**SPADINA MUSEUM
GARAGE
REHABILITATION**
285 SPADINA ROAD TORONTO, ON

MECHANICAL TENDER ADDENDUM M-01

October 3, 2023

PROJECT: Spadina Museum Garage Rehabilitation and Site Accessibility
LOCATION: 285 Spadina Road, Toronto, ON M5R 2V5
Client Project #: A22048
M4S Project #: 22626

Drawing title
**GROUND FLOOR –
PLUMBING – DEMOLITION
AND MODIFICATION**

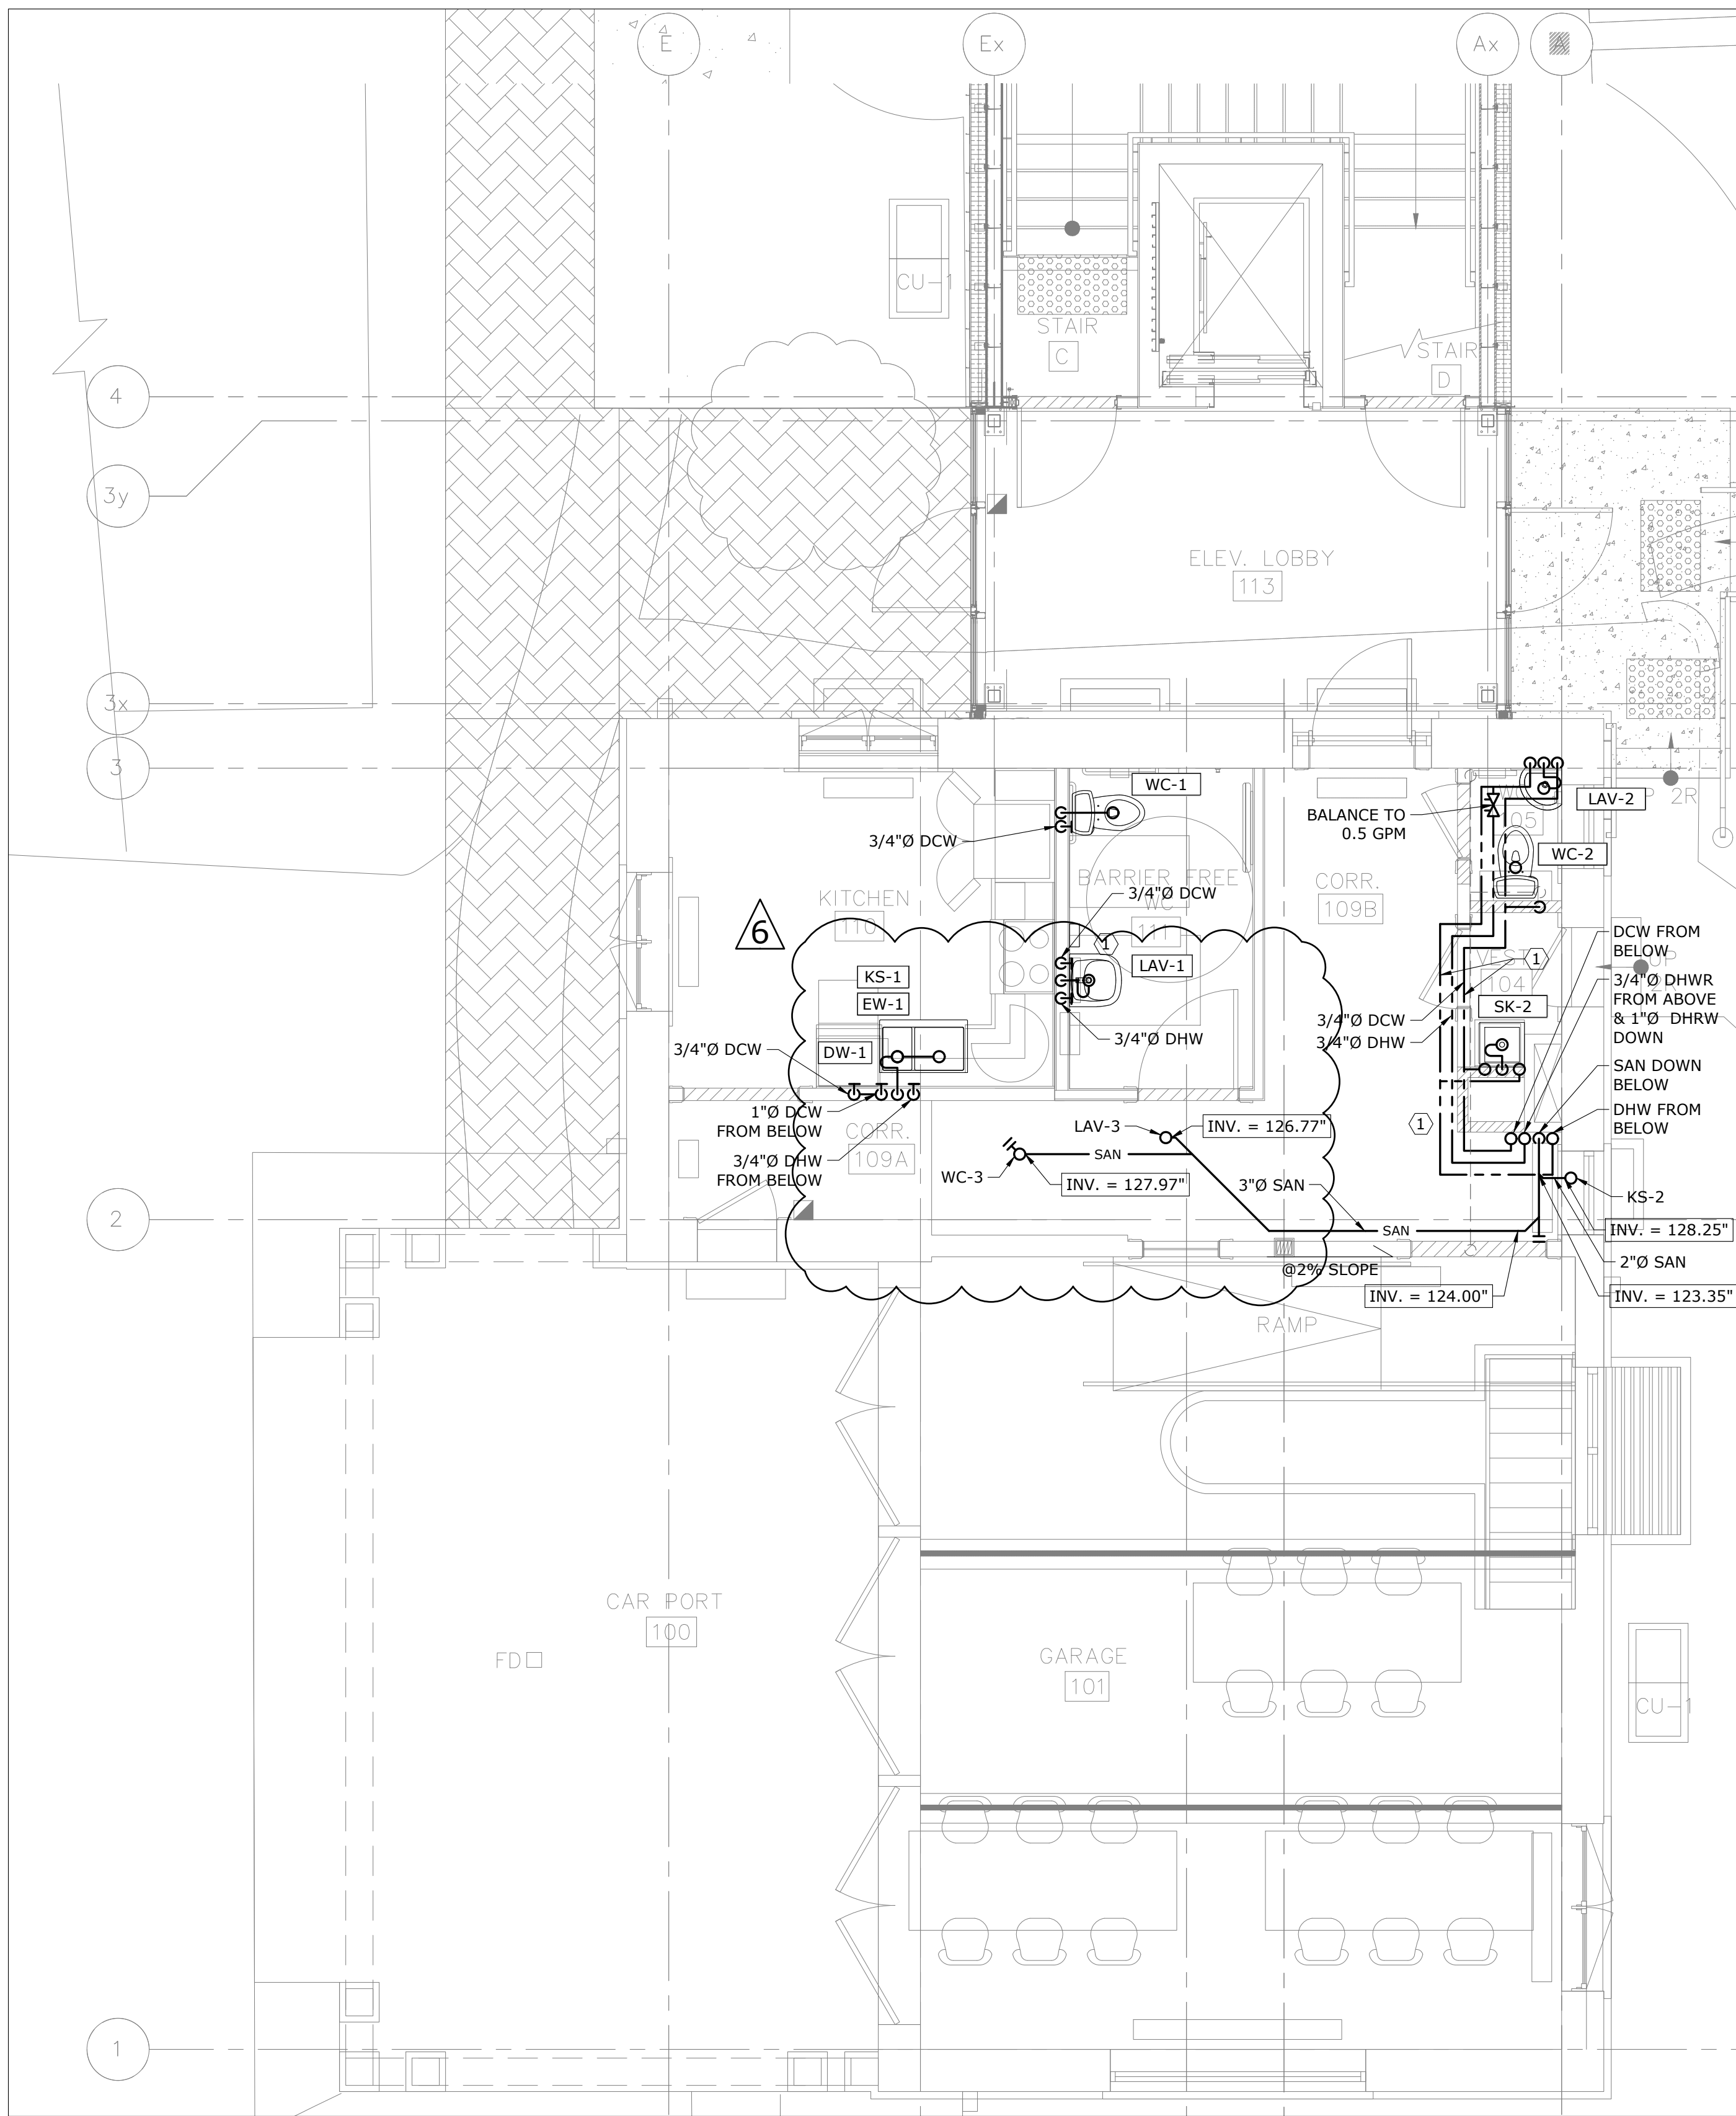
- Relocation of eye wash station (EW-1).
- Revision of sanitary piping layout above grade.

Drawing title
**SECOND FLOOR –
PLUMBING – DEMOLITION
AND MODIFICATION**

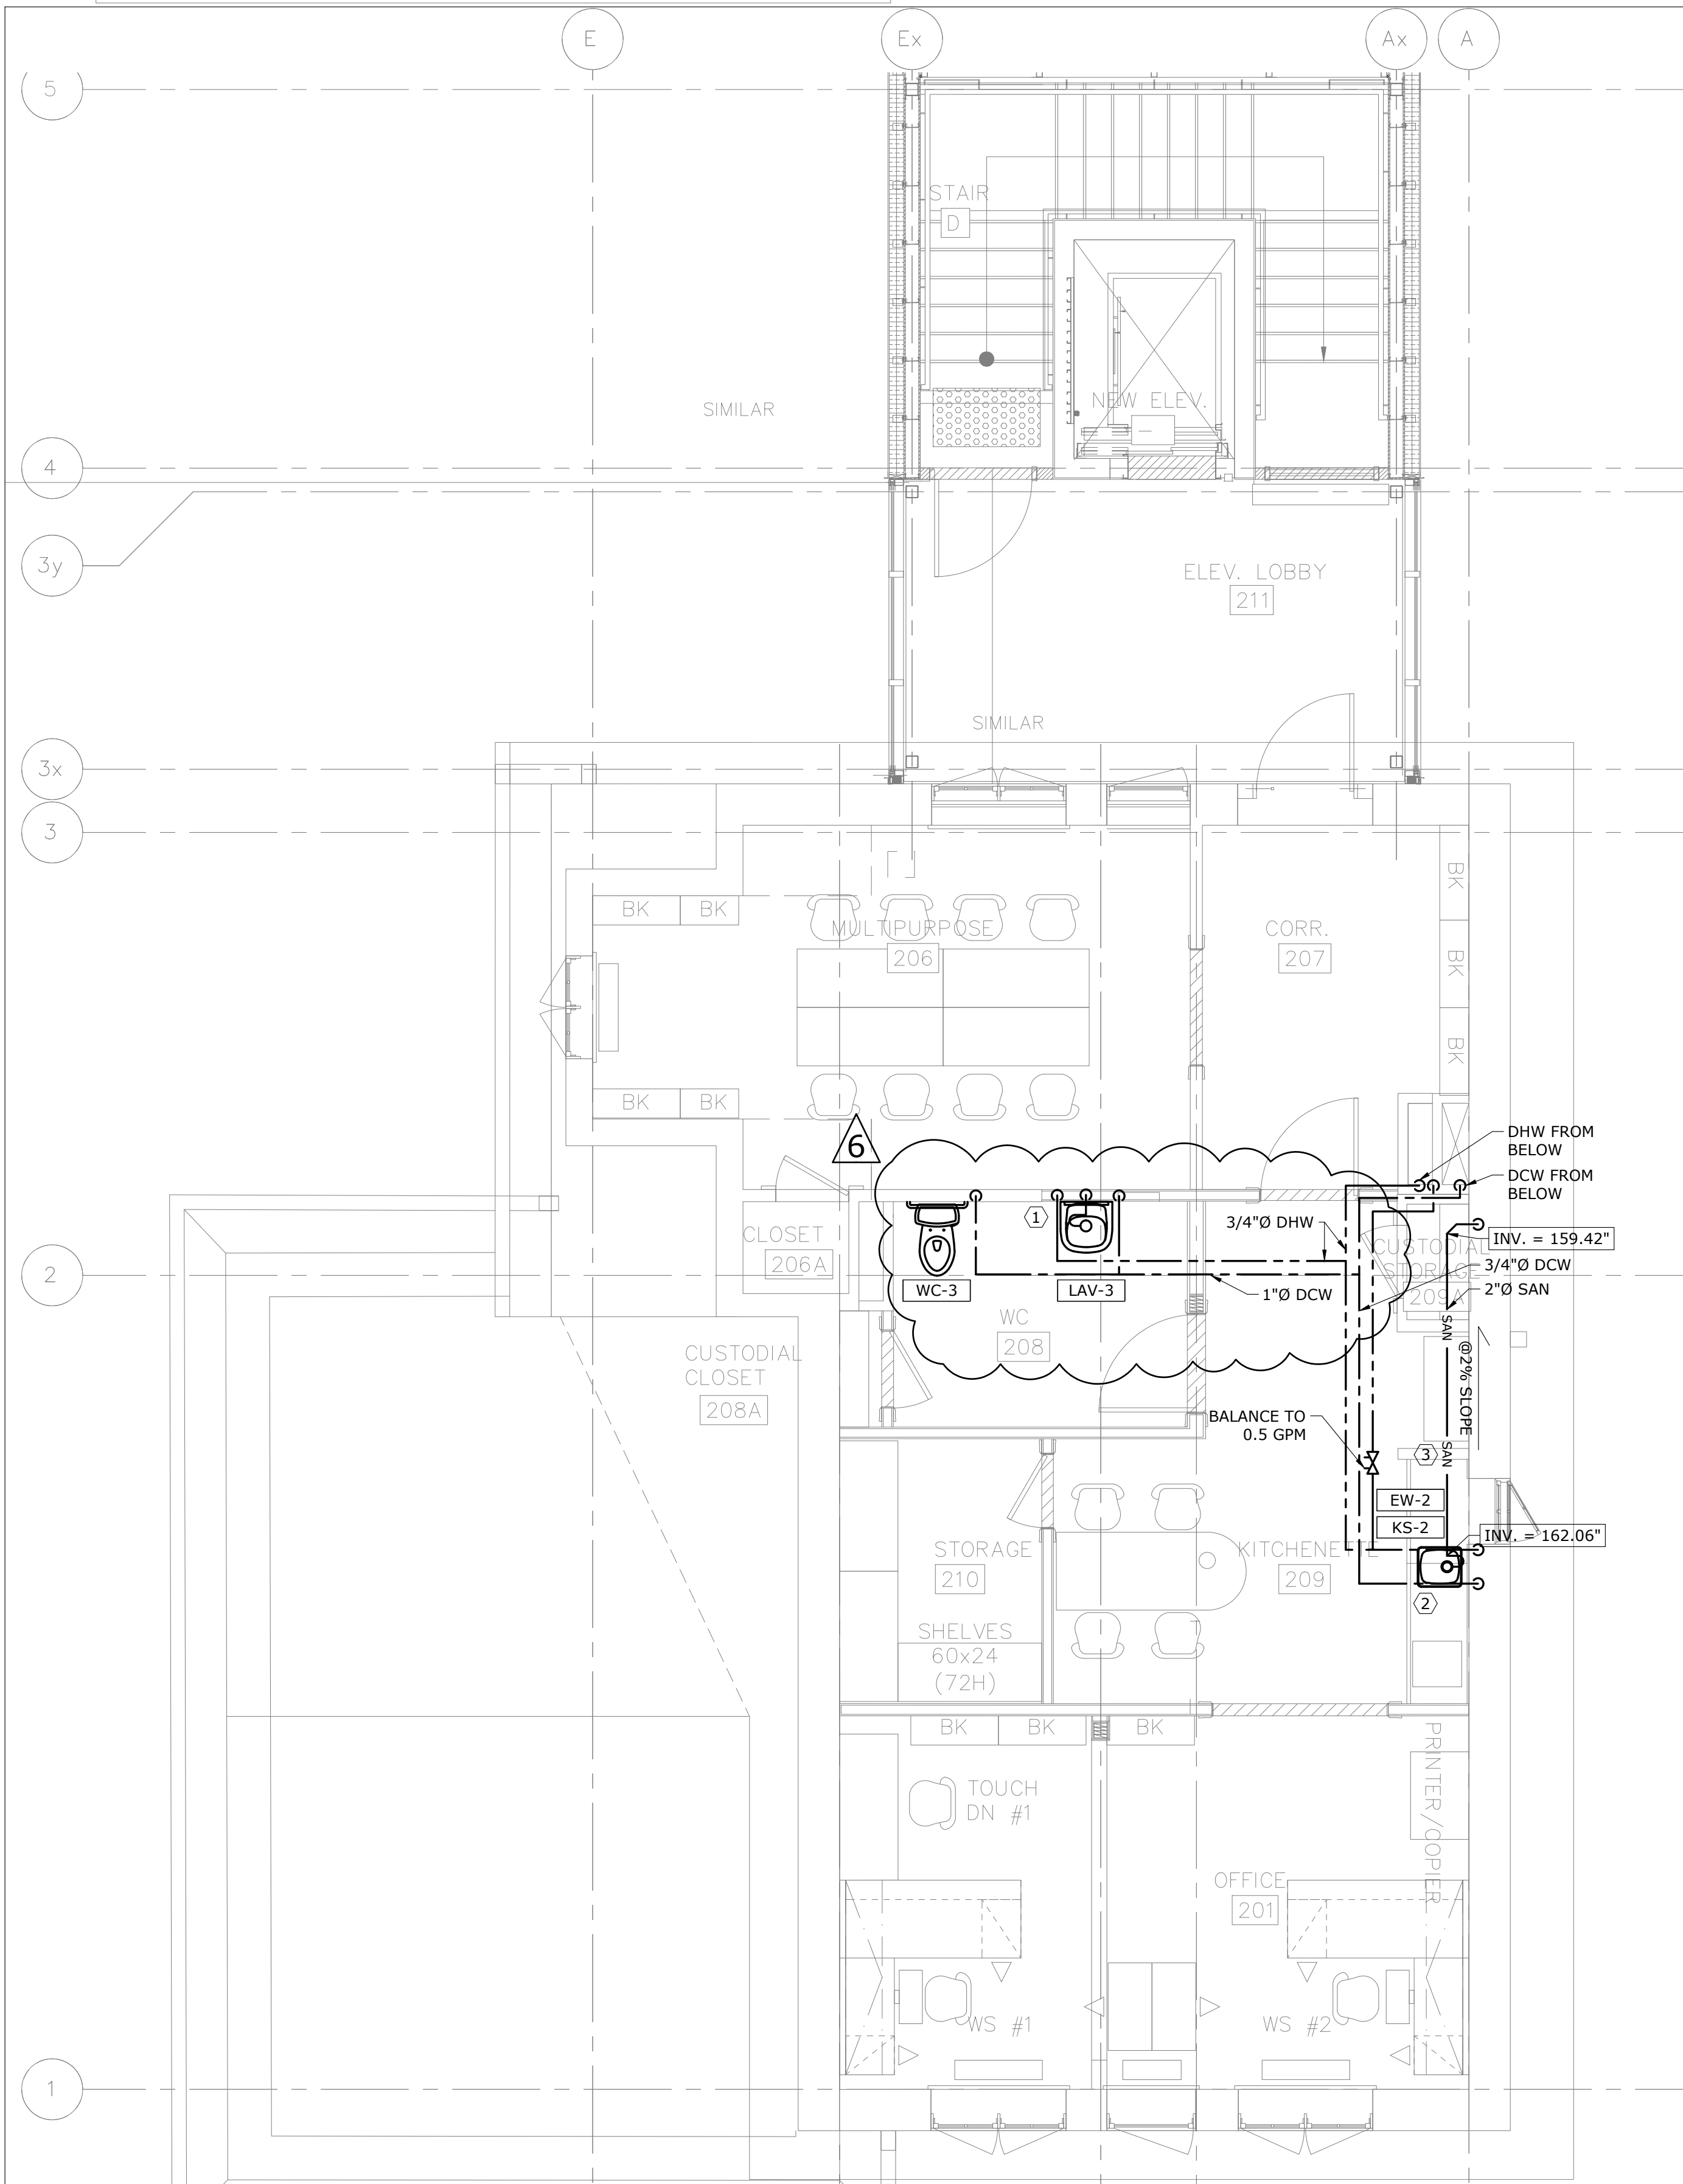
- Reconfiguration of 2nd floor washroom layout and domestic water piping.

Drawing title
**GROUND FLOOR - HVAC -
DEMOLITION AND
MODIFICATION**

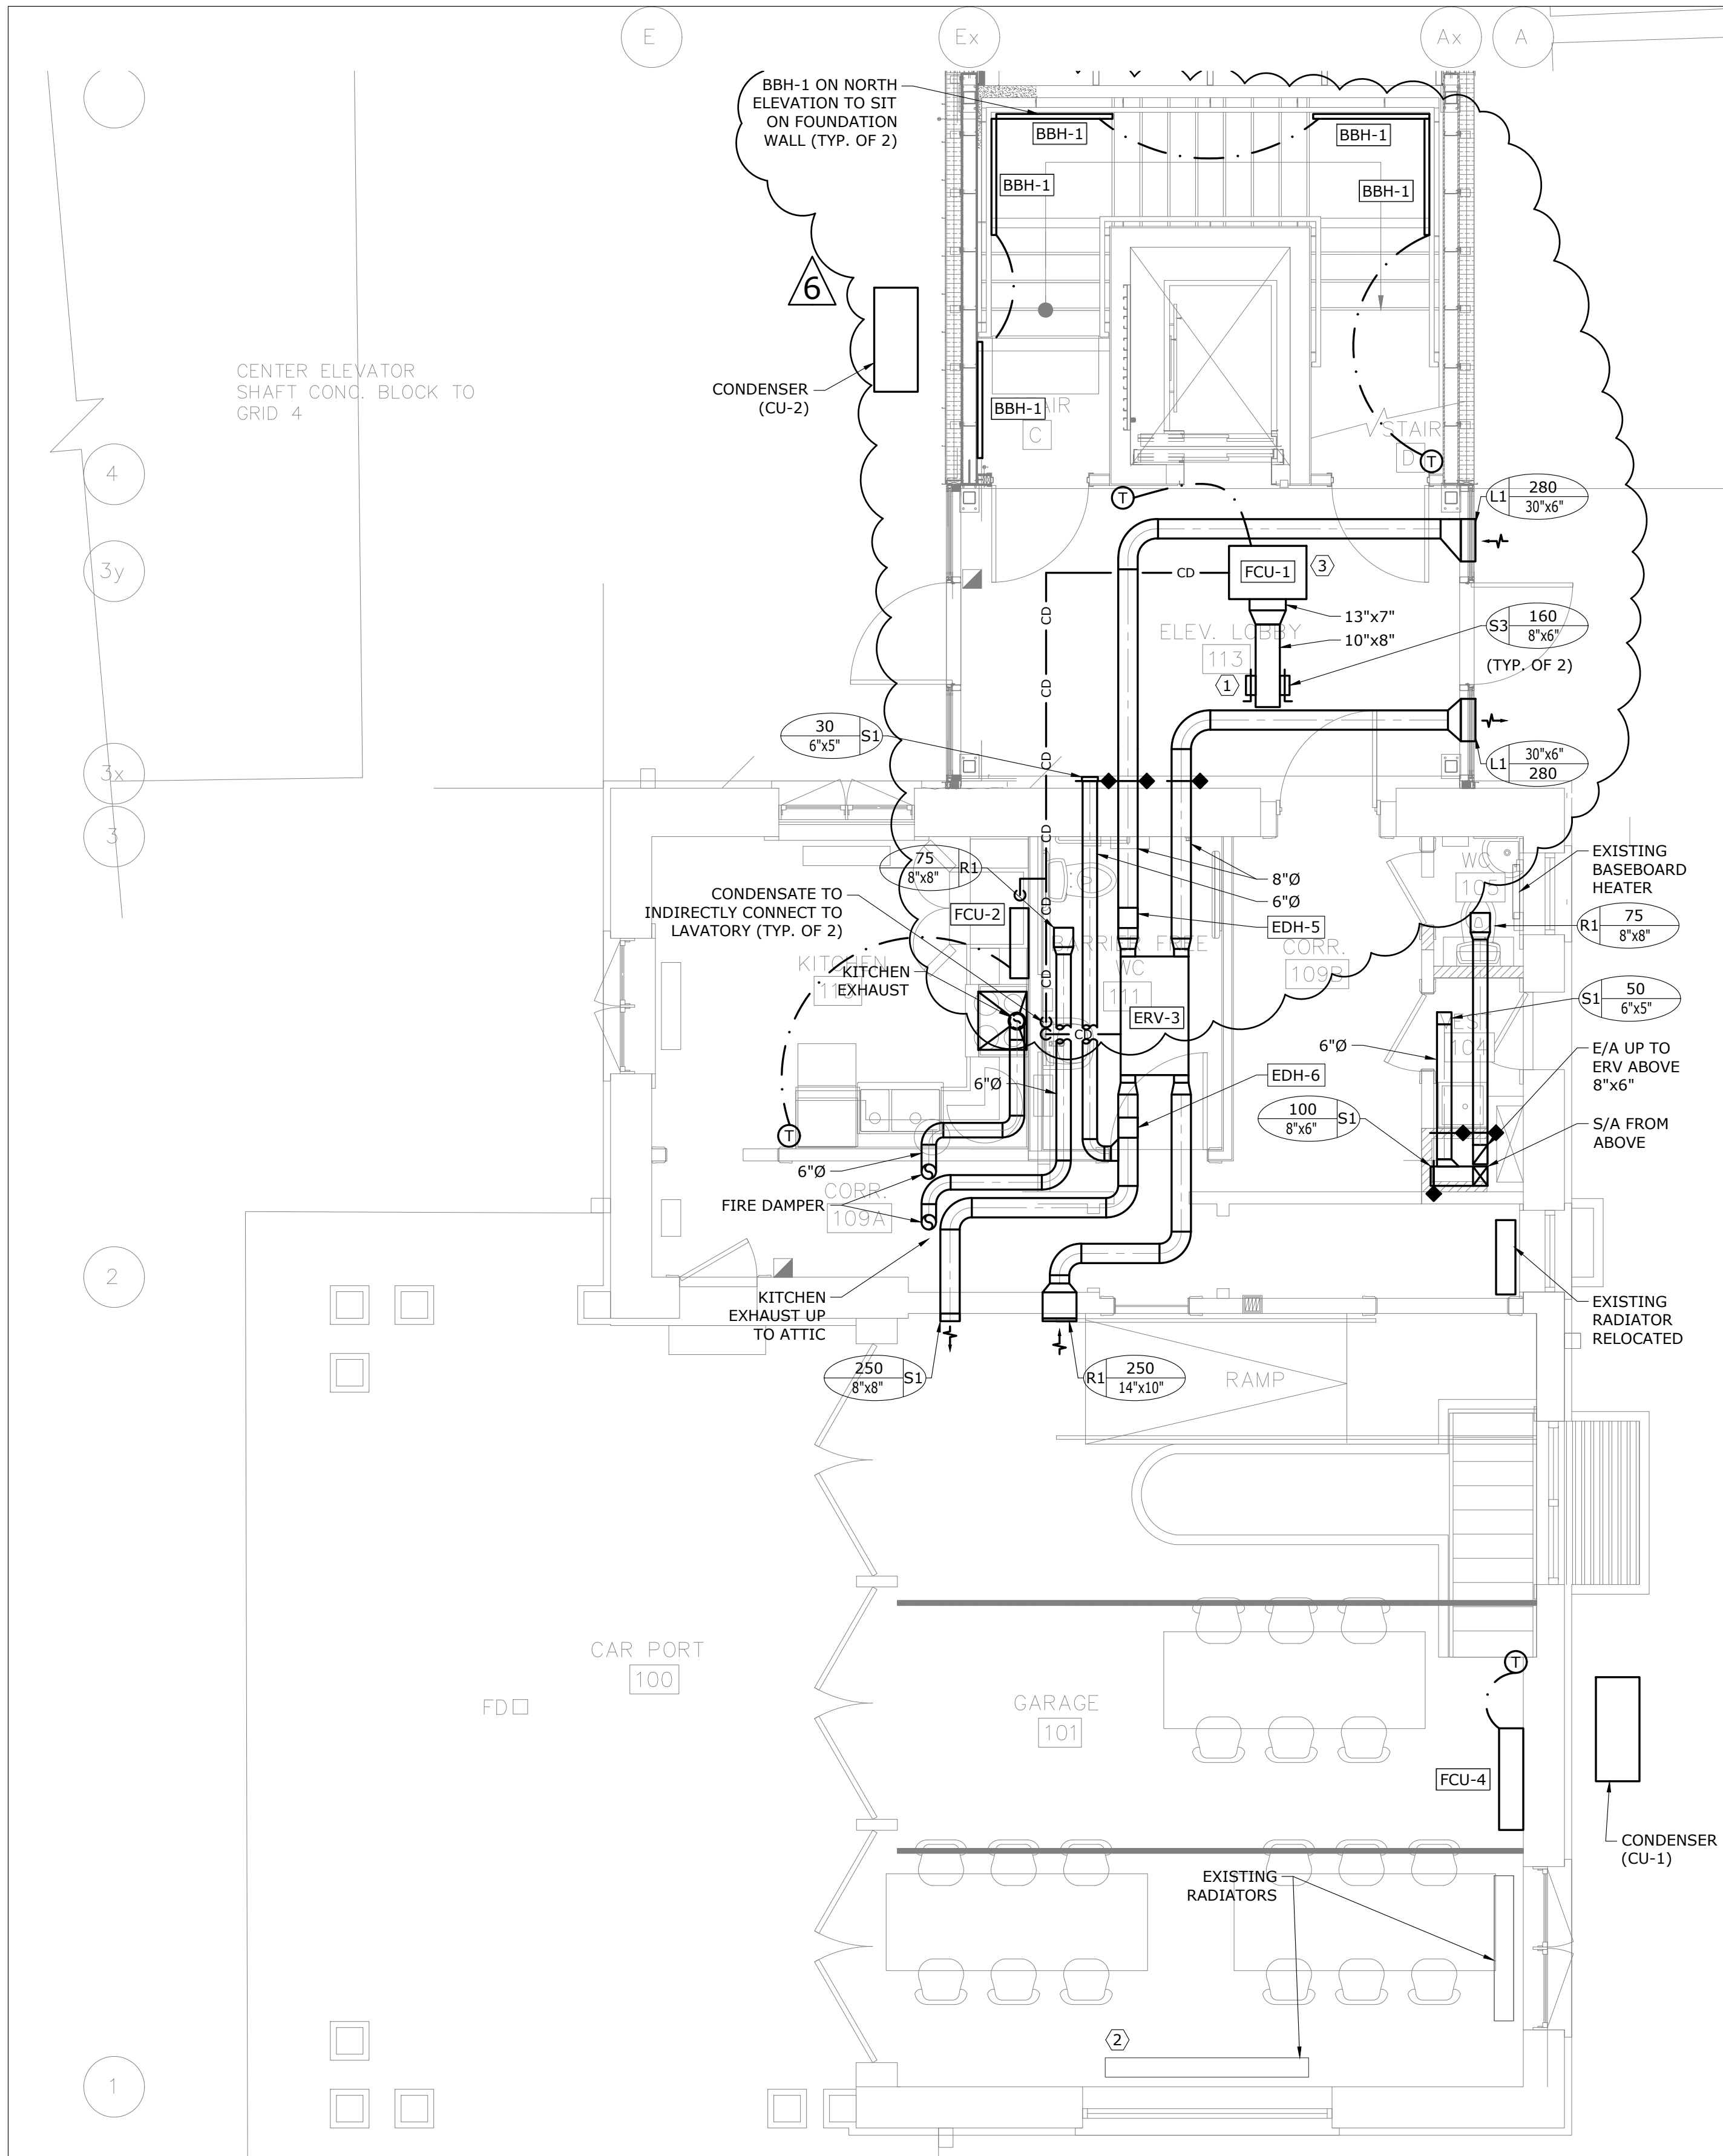
- Reconfiguration of the ERV and fan coil unit duct layout.
- Revision to the baseboard heater and thermostat locations.
